TWISTER

FIELD INSPECTION POINTS

SERVICE BULLETIN

Ride: TWISTER

Subject: HEAD REST INSPECTION

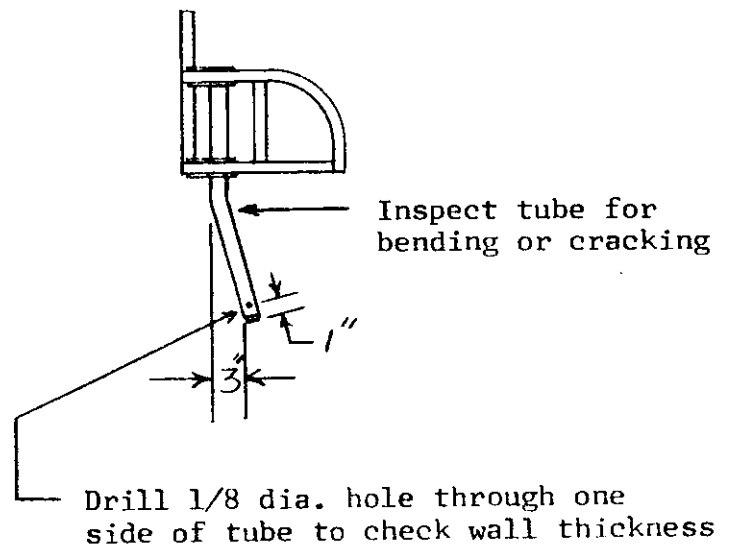
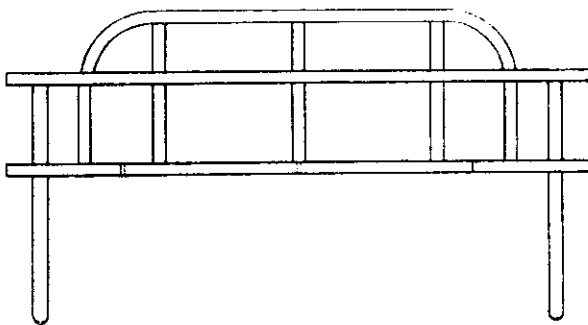
All TWISTER owners must inspect the head rests on all TWISTER cars immediately. Remove each head rest and inspect the support tubes that fit down in the sockets on each car. Inspect for any signs of physical damage, such as bending or cracking. Next, drill a small hole, 1/8 inch, near the bottom of the support tube approximately 1 inch from bottom. Drill hole through one side of the tube only. Check wall thickness of tube. It should be 1/8 inch thick.

If any of the tubes show signs of bending or cracking, or if any tube has less than a 1/8 inch wall, immediately report such condition to Mr. Richard G. Chance, General Manager, Chance Manufacturing Company.

Inspect the head rest support tubes on a regular weekly basis as an added measure of safety.

Ride: TWISTER Subject: HUB EAR REPLACEMENT

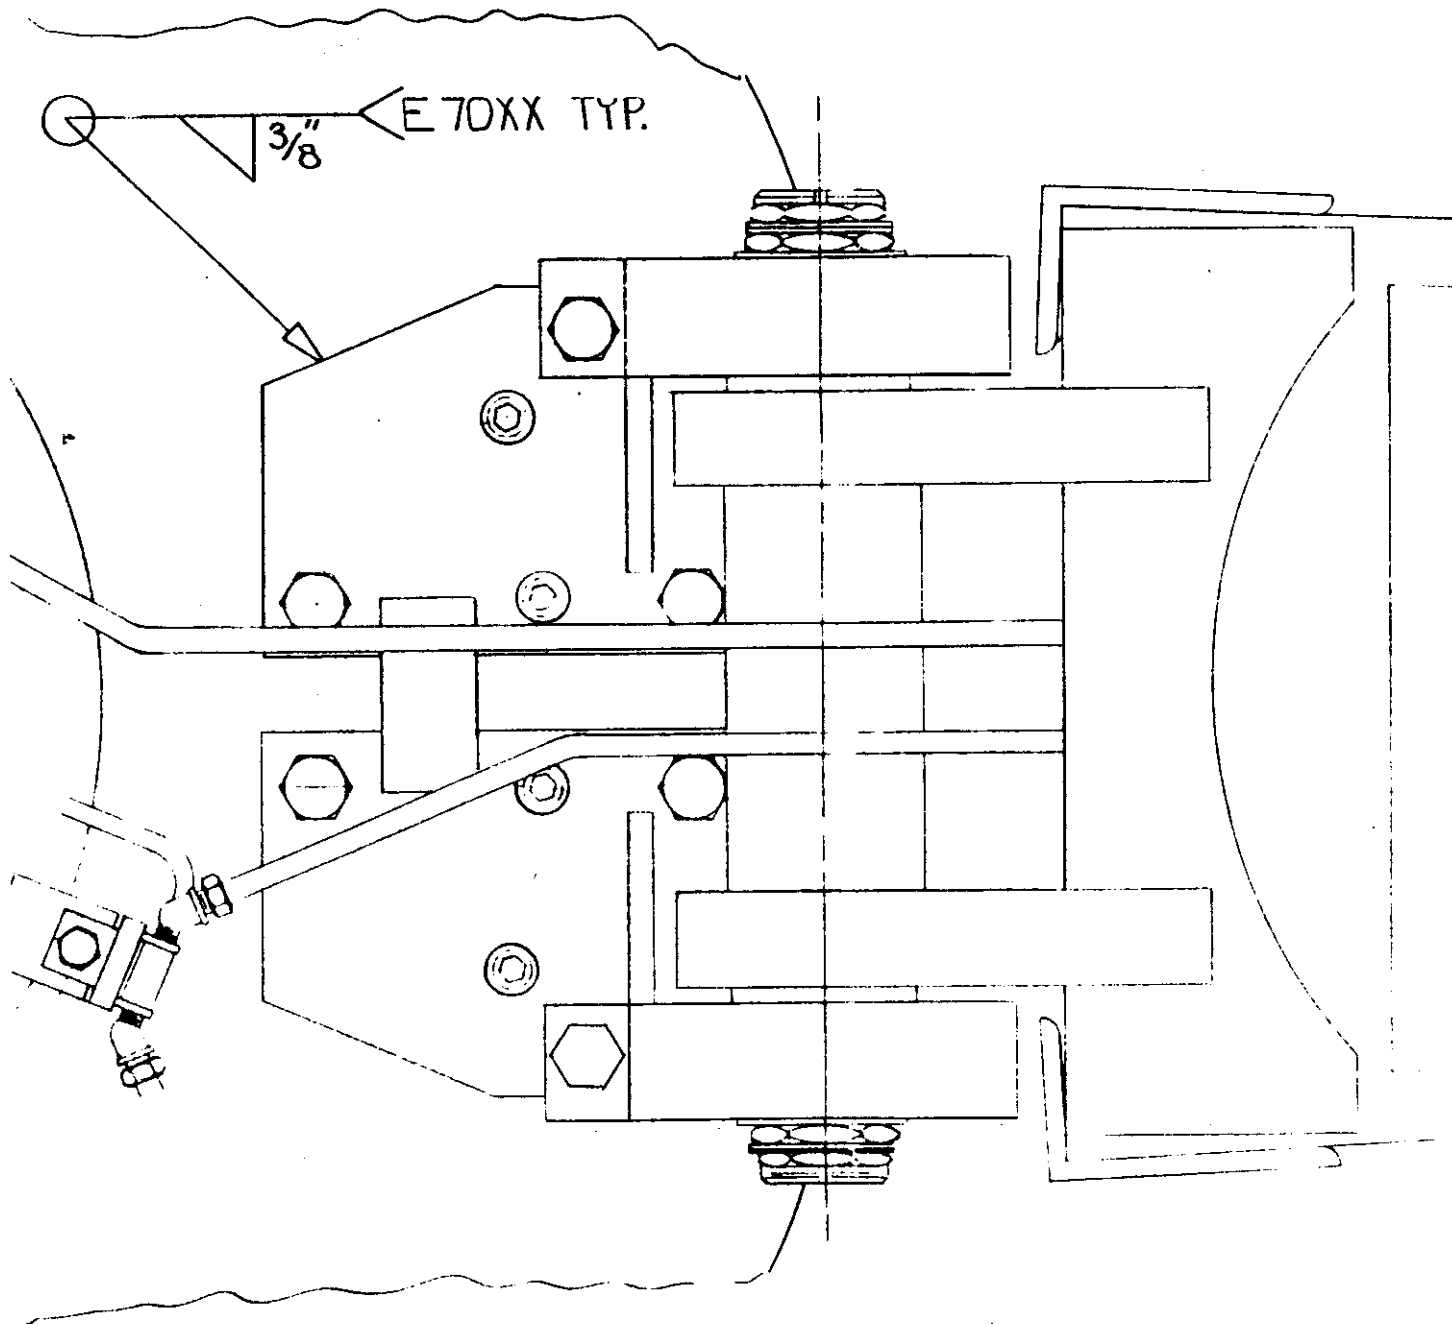
With ride set up remove outer sweep. Fold stub sweep up and lock into place. Use an air arc to cut the broken ear loose around the outer edge of hub plate. Lower stub sweep and cut broken ear loose all the way around.

Disconnect air hose and wiring from stub sweep. Remove nuts bearing and seal from good ear on opposite side of sweep. Remove bolts from broken ear. Remove stub sweep and broken ear. Grind hub plate smooth.

Remove broken ear from stub sweep. Place bearings from broken ear along with new seal into new ear. Place outer attaching bolt in new ear and install new ear onto shaft. Start nuts onto shaft but do not tighten.

Install stub sweep and new ear on hub plate. Insert bearing along with new seal in opposite ear. Start adjusting nut on shaft but do not tighten. Start all bolts in new ear but do not tighten. Shove new ear as far as possible away from opposite ear and tighten bolts.

Tack weld new ear to hub. Check adjustment of bearings and then weld ear to hub all the way around.

All welding must be performed by a welder that is certified under the American Welding Society Structural Welding Code D1. 1-75 or the equivalent.

Check torque on ear attaching bolts. Check bearing adjustment and lock adjustment in place. Install hoses, electrical connections and outer sweep.

EXAMPLE OF CONTROL PANEL
All control panels do not look alike.

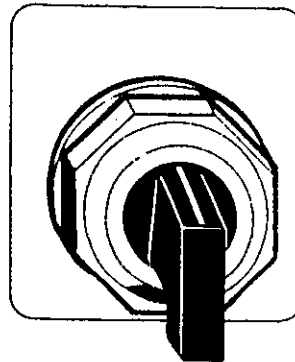
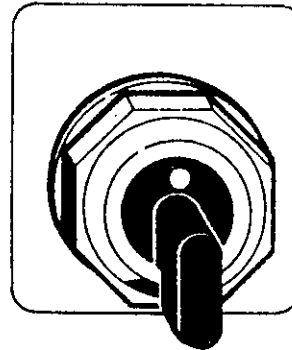
Chance Rides, Inc. has determined, through field experience, that the three-position swing knob switches used on many Chance Rides, Inc. products may not meet our specifications. These swing knob switches are located on the operator's control panel and can be identified as those knobs which have three positions, the center position being the neutral position with the knob automatically returning to that position by means of a spring. These swing knob switches require routine inspection to insure the spring is functioning properly in returning the knob to the center position. If the spring breaks, the knob will not return to the center position. If the knob does not return to the center position, the ride may not function as the operator expects, resulting in possible injury to the operator, attendants and/or passengers.

Chance Rides, Inc. is now using a new three-position swing knob switch and requires all owner/operators of Chance Rides, Inc. products with three-position swing knob switches to order and install the new replacement knobs and mating contact blocks. Refer to the chart on this bulletin to help identify those rides having swing knob switches which need to be replaced, along with the quantity of swing knob switches and the number and kind of contact blocks required for each ride as well as the appropriate part numbers for each item. The cost of these new style swing knob switches and contact blocks will be credited back to the purchaser if the old style swing knob switch is returned to Chance Rides, Inc. within ninety (90) days of the date on this bulletin.

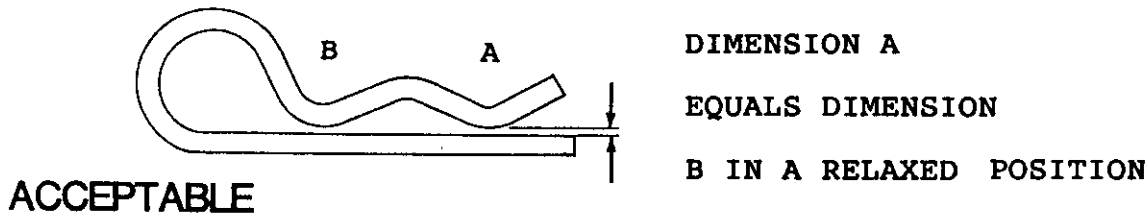
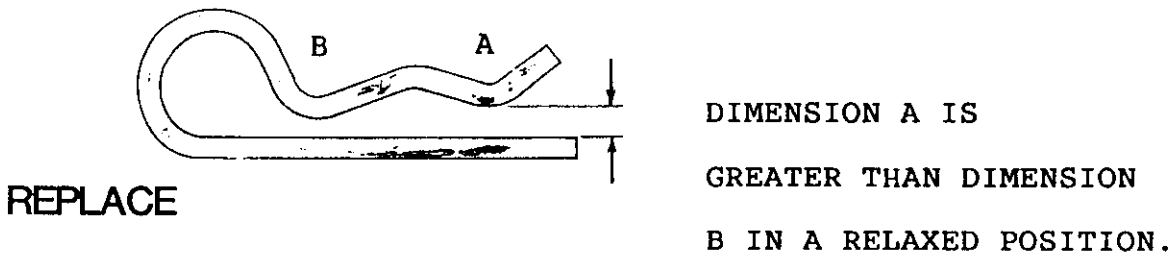
All keepers (R-keys, hair pins, lynch pins, etc.) must be inspected for wear. If any keeper is bent out of shape or sprung, as shown in Illustration B, it must be replaced.

NEVER ATTEMPT TO BEND A HAIR PIN BACK INTO SHAPE.
REPLACE IT WITH A NEW PART.
